Spartan RV Chassis

Technical Service Bulletin
CSB21-340-001

<u>DATE:</u>	March 11, 2021
<u>APPLIES TO:</u>	This service bulletin applies to certain 2018 through 2022 model year K2, K3 and K4 model Spartan RV motor home chassis built between May 7, 2018 and December 3, 2020 that are equipped with RTS and RTSe rear suspensions supplied by Reyco Granning, LLC.
<u>CONDITION:</u>	RTS and RTSe rear suspension component identified below is under desired torque value.
<u>CORRECTION:</u>	See details below.
<u>LABOR ALLOCATION:</u>	Up to 1 hour
<u>CLASSIFICATION:</u>	V3
<u>TOOLS NEEDED:</u>	Calibrated torque tool capable of applying 770 lbs-ft +/- 25 lbs ft.

Figure 1

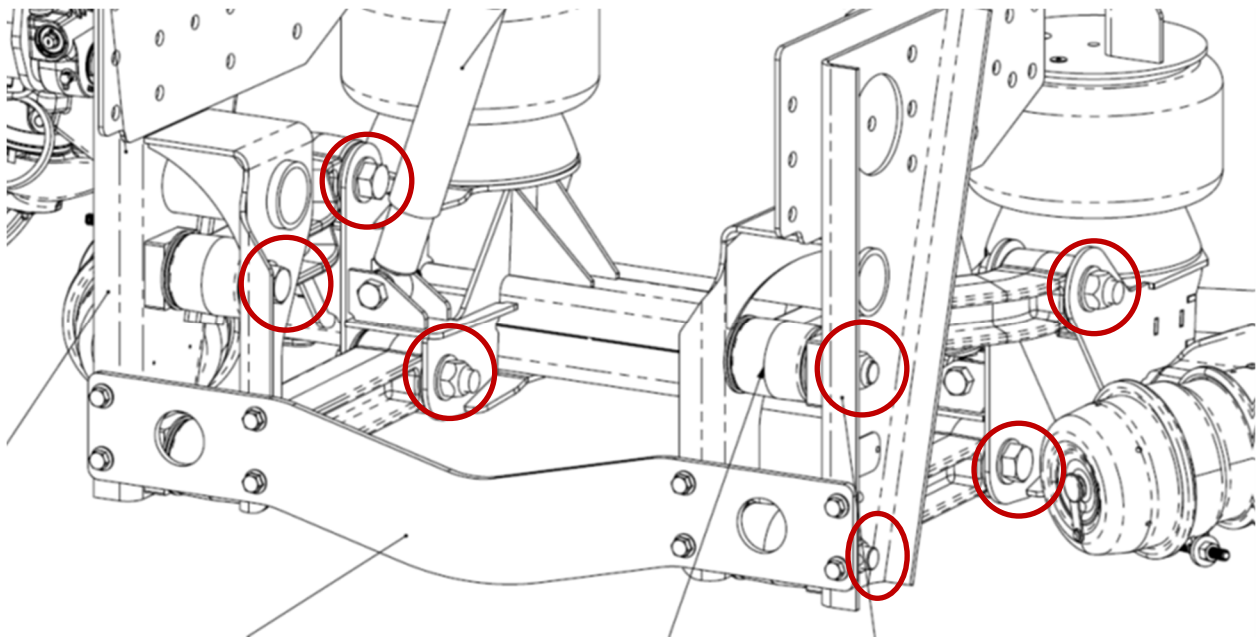
1. Referring to Figure 1, from the nut side of the eight (8) fasteners, torque the fastener to 700 lbs ft, +/- 25 lbs ft.
2. If the nut side of the fastener is not accessible, torque the bolt side of the eight (8) fasteners to 770 lbs ft, +/- 25 lbs ft.

Note: There are a total of eight (8) fasteners to be torqued. Only seven (7) are visible in Figure-1.
